Access Compliance Report

Public Rights-of-Way

(Curb Ramps)

Intersection ID: 29178	Main Street: HARRIS_CENTER_DR	Cross Street: STATESVILLE_RD	Location: W
ADA ID: 793E898EA492	Ramp Type: Perp	Initial Pass/Fail: Fail	Overall Compliance: No
		Severity Score: 25

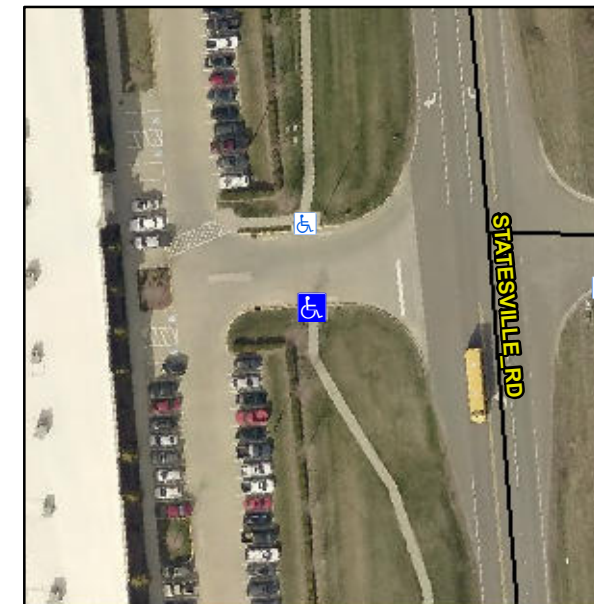
R304.2.2, R304.5.3

Compliance	Description	Data	Compliance	Description	Data
N/A	Ramp Length (in)	98.0	No	Ramp Slope (%)	9.0
Yes	Ramp Width (in)	48.0	No	Ramp XSlope (%)	5.6
N/A	Flare Type LT	N/A	N/A	Flare Type RT	N/A
N/A	Flare Slope LT (%)	N/A	N/A	Flare Slope RT (%)	N/A
N/A	Flare Traversable LT?	N/A	N/A	Flare Traversable RT?	N/A
N/A	Landing Length (in)	N/A	N/A	DWS Provided?	N/A
N/A	Landing Width (in)	N/A	N/A	DWS Contrast?	N/A
N/A	Landing Slope (%)	N/A	N/A	DWS Length (in)	N/A
N/A	Landing X Slope (%)	N/A	N/A	DWS Full Width?	N/A
N/A	Landing Curb? (Y/N)	N/A	N/A	DWS Offset (in)	N/A
N/A	Shared Landing?	N/A			
N/A	Gutter Ponding?	N/A	N/A	Gutter Slope (%)	N/A
N/A	Gutter Lip Ht (in)	N/A	N/A	Gutter X Slope (%)	N/A
N/A	Painted X Walk1?	No	N/A	Painted X Walk2?	N/A
	X Walk 1 Direction	To N		X Walk 2 Direction	N/A
N/A	X Walk 1 Width (in)	N/A	N/A	X Walk 2 Width (in)	N/A
	X Walk 1 Slope (%)	1.7		X Walk 2 Slope (%)	N/A
	X Walk 1 X Slope (%)	5.6		X Walk 2 X Slope (%)	N/A

Remove & Replace Entire Ramp.
